egusphere-2024-863 response to Anonymous Referee #1 with revisions

In this paper, the authors combine the JULES model, which solves the glacier energy balance, with OGGM, which simulates ice flow, and investigate the mass balance over 500 tropical glaciers in the Vilcanota-Urubamba basin in Peru. Specifically, the authors calibrate the surface energy balance model parameters based on 30 glaciers during the period of 2000-2018 and project the mass balance for all glaciers in the region until 2100 with RCP4.5 and RCP8.5. They find that sublimation plays a minor role in glacier evolution at the basal scale, and their mass balance projections are more conservative than previous models. For example, the JULES-OGGM model estimates that 17% of the ice mass will remain by 2100 under RCP4.5, while other models (GloGEM and MAR2012) predict this number to be only 2%.

egosphere-2024-863 response to Anonymous Referee #2 with revisions

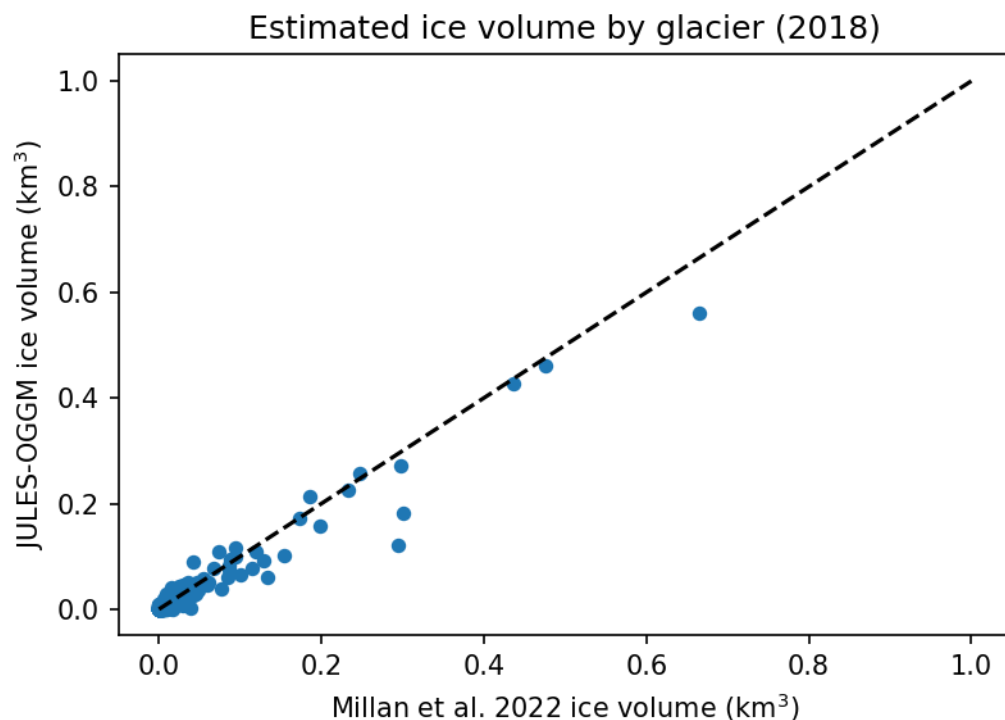
There might not be in situ glacier thickness measurements for these glaciers, however, the authors could check how their simulated initial ice volumes or ice thickness distributions compare to those from Millan et al (2022) at least for glacier wide volume estimates. Millan et al (2022) is a satellite derived ice thickness product and uses, like OGGM, mass conservation and the SIA, these are not in situ ice thickness observations but if compared to model initial model simulations could provide an idea of the calibration error for the ice dynamic part of the workflow. In other words, errors derived by not calibrating ice dynamical parameters in OGGM or by not updating glacier geometry changes in JULES. By looking at Millan et al (2022) Figure 3b seems to be data available for C Vilcanota glaciers. I encourage the authors to make such a comparison as this could strength the findings of the manuscript.

Having looked at the Millan et al. (2022) study, this looks like a promising basis to do a glacier-specific validation. Having read the manuscript in detail, we would highlight several important considerations of using these data:

- 1) Their ice thickness estimates would not permit the validation of the initial ice geometry specifically as suggested by the referee. This is because their calculations are derived from maps of ice velocity are estimated from the years 2017-2018. Our simulations are initialised for the year 2000.
- 2) They note that the “temporal mismatch” between the ice velocity product, digital elevation model and glacier outlines are important sources of uncertainty which can't easily be quantified. An important component of this is the glacier outlines. They use the same outlines as our initial glacier area (for the year 1998).
- 3) Errors in ice thickness for thicknesses below 100 m (this accounts for 95% of the glacierised area in the VUB according to this study) are assumed to be >50%.

While there are undoubtedly limitations of using these data, they are the current state-of-the-art and, therefore warrant being used in our analysis. We were keen to conduct this analysis, even before submitting our revisions, and so have done so considering this suggestion. In the figure below, the Millan et al. (2022) ice volume data are plotted against the JULES-OGGM simulation for 2018 for all glaciers. As we note above in limitation 1, we can't use these to validate the initial geometry specifically, but this comparison does implicitly validate this as well as the dynamic behaviour of the model over the 2000-2018 simulation period. Most simulations sit close to the 1:1 relationship (black dashed line). The total JULES-OGGM ice volume for glaciers where Millan data are available (not all glaciers in the VUB) is 7.19 km³ whereas Millan et al. (2022) estimate it as 8.16 km³. The lower estimated volume is perhaps not surprising, especially due to much older glacier outlines used to estimate these. **We will include this analysis and discussion of the limitations of the data and modelling approach in the discussion.**

We have included this in the revised manuscript. We first introduce the data in the methodology section (L133):

We then include the analysis in a new results section (L397). Note that we have changed the figure to a log scale so that discrepancies for lower-volume glaciers are easier to see. We’ve drawn from this new analysis in our discussion (L653) as part of our consideration of the reasons for differences between our simulations and those of GloGEM and MAR2012:

“For the initial ice volume, it is important to note that our simulated ice mass for the year 2000 lies somewhere between that of GloGEM and MAR2012 (Figure C 1c and d) which suggests that this is not a principal driver of the differences in our simulations to these models. Certainly, when we compared our ice volume simulations for 2018 against the estimates of Millan et al. (2022) the level of agreement was encouraging, but there were some discrepancies, especially for the smallest glaciers where the JULES-OGGM simulations generally underestimate glacier volume. Even so, there are significant uncertainties in the Millan et al. (2022) ice volume estimates, given the temporal mismatch in input data. They also note that errors in ice thickness (and thus volume), for thicknesses below 100 m, which accounts for 95% of the glacierised area in the VUB, are assumed to > 50%.”
